COMMONWEALTH OF AUSTRALIA.DEPARTMENT OF TRANSPORTAIR TRANSPORT GROUPAIRWORTHINESS DIRECTIVE - GLIDERS

GFA/AD 53/LET 5

Glider Types affected - L-13 Blanik (all serial numbers)Subject:

Amendment to the maximum time in service between major inspections (G.F.A. Form 2 inspections) and amendment to flight manual airspeed values in annex 2 Performance Characteristics - refer Pilot's notes for the L-13 Sailplane, 2nd and 3rd edition.

1

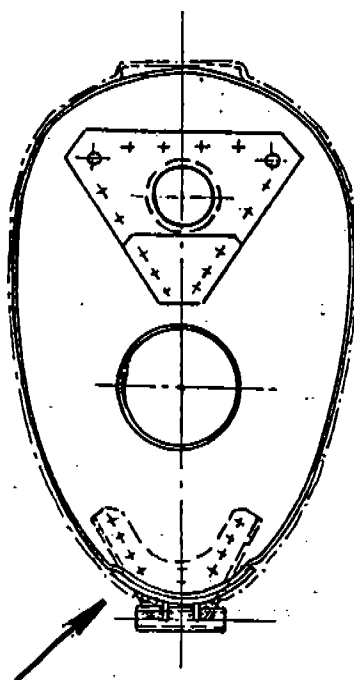
3. Check the bottom flangeplate of the centre-section spar for water penetration (see Fig. 1). Wipe out water, if any, and check for corrosion. Clean the affected spots using emery cloth and coat with varnish. Seal the gap between the rib and the fitting on the fuselage with fabric strip.

2

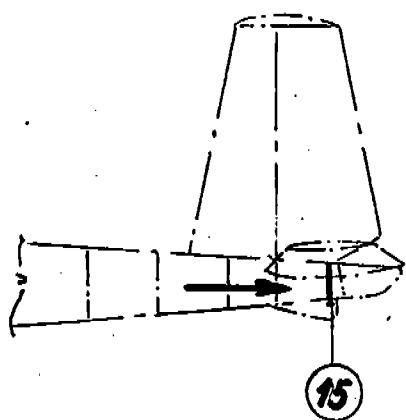
5. Check the bulkhead No. 15 for cracks in the area of tail-skid suspension. (See Fig. 2) Two cracks of 10 mm max. in length are permissible in the lower part of the bulkhead in the area of tail-skid suspension. In such a case, holes must be drilled into the ends of the cracks using a 2.1 mm dia. drill. If the length of cracks exceeds 10 mm or if there are more cracks found, it is necessary to replace the bulkhead.

3

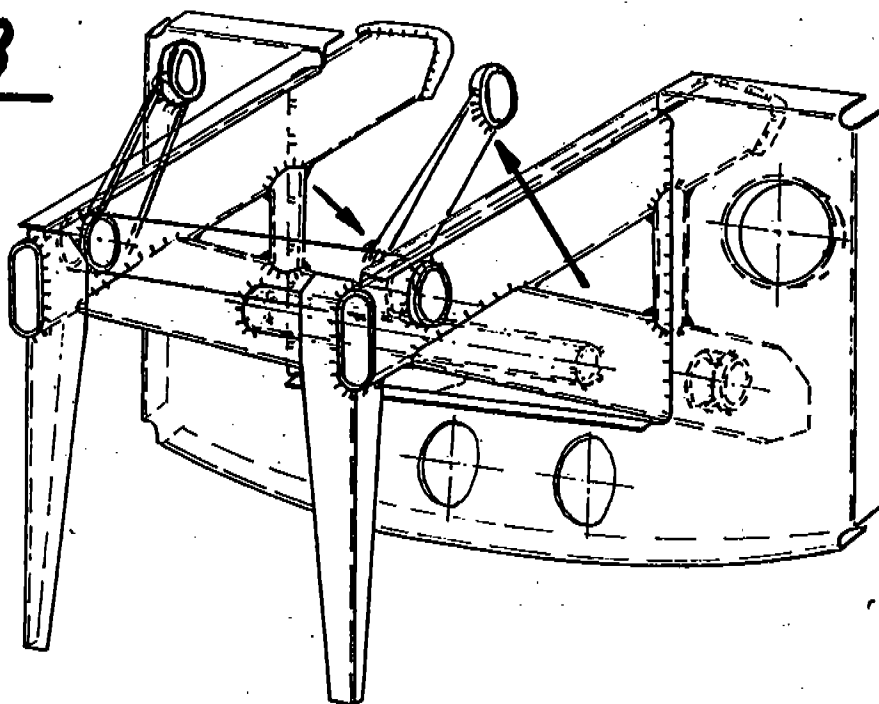
6. Check the tail-skid rubber shock absorber. Replace if torn up.
  7. Check the pivoted suspension of the undercarriage shock absorber and the single-arm lever (see Fig. 3) for cracks. Check all welds - replace defective parts.

4

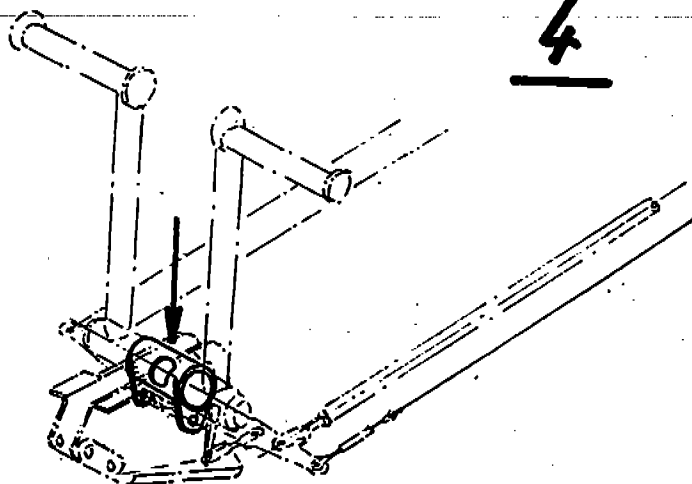
8. Check the rocker arm of the front pedal unit for cracks (See Fig. 4). Replace if cracks are found out. Check the clearance of the pedals. If larger than 2 mm, the pedals must only be set in the two extreme positions.

5

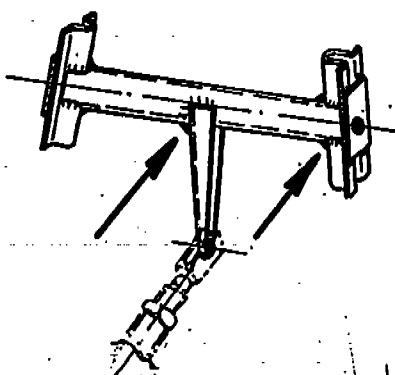
10. Check the elevator actuating arm for cracks (See Fig. 5). Replace if cracks are found out.
  11. Check the stiffeners for cracks in the areas marked by arrows (See Fig. 6). Replace if cracked.

7

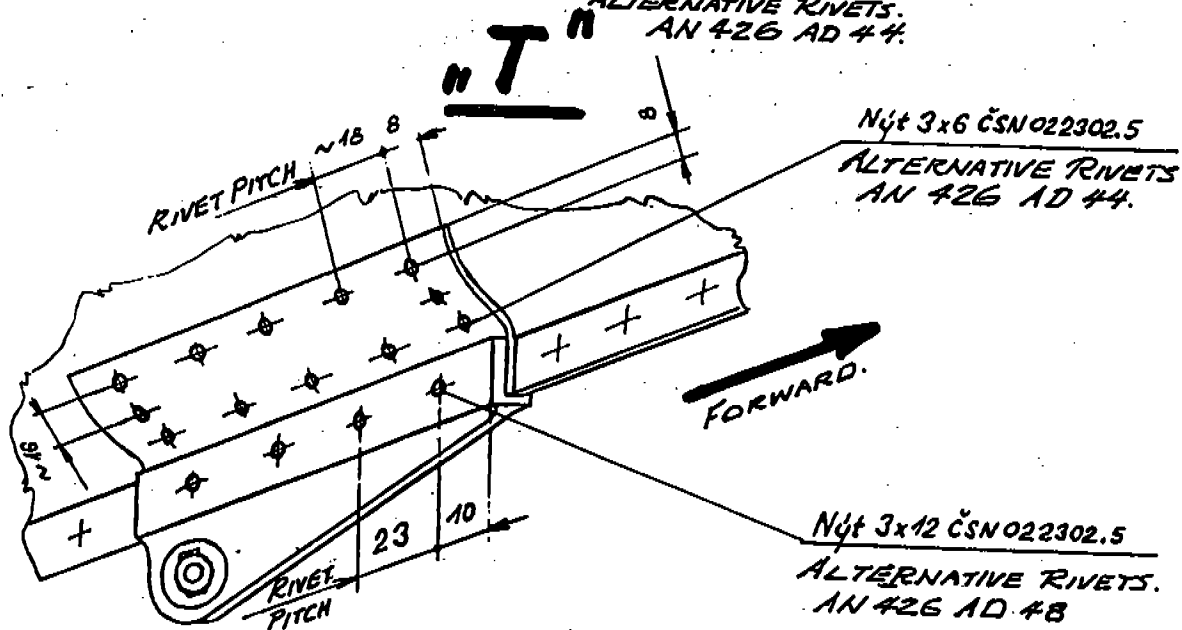
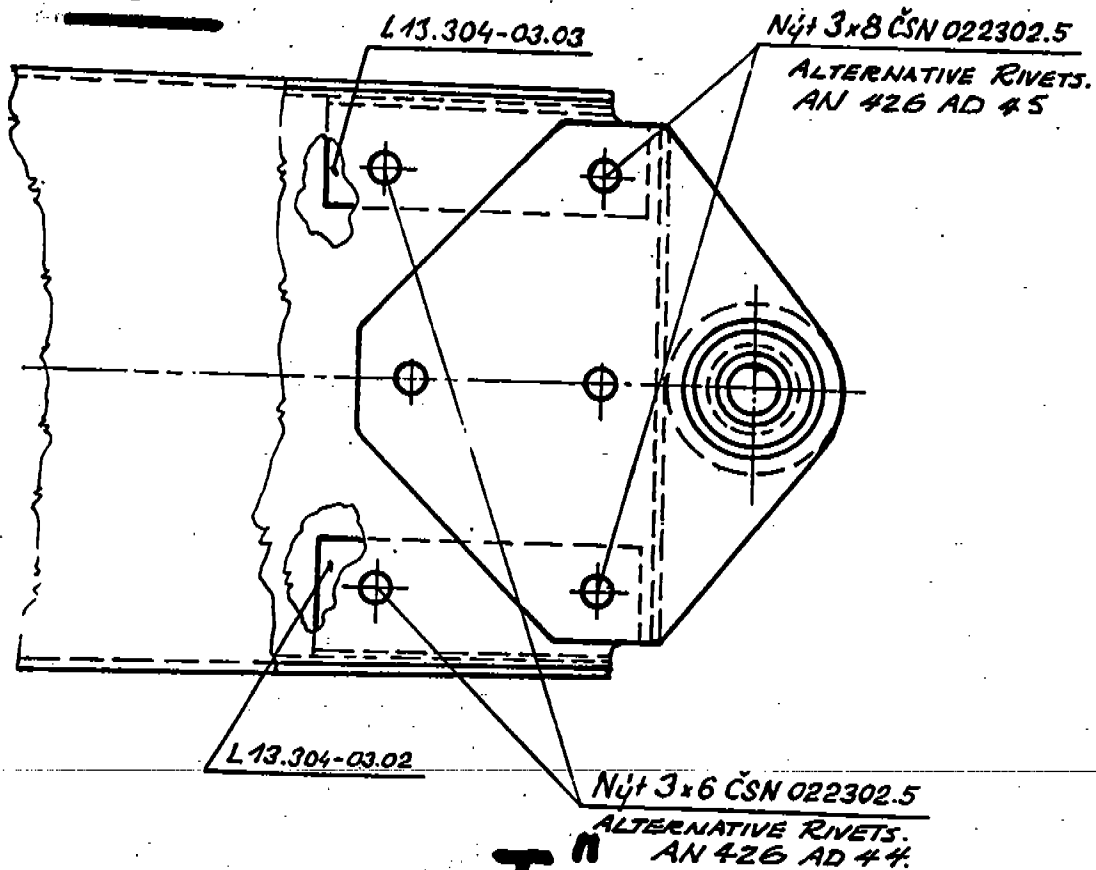
12. Inspect the front suspension of the tail skid, check its attachment. If damaged, replace it by a new one, SK-L 13.165, and reinforce the attachment area of both sides of the fuselage by means of a 0.8 mm thick, 60 x 100 mm size sheet, made of B16T material (See Fig. 7, detail T).

- 
13. Check the upper suspension lug of rudder and its vicinity for cracks. Reinforce the cracked areas, if any, by means of angle irons L 13.304 -03.02. (See Fig. 7, View S).
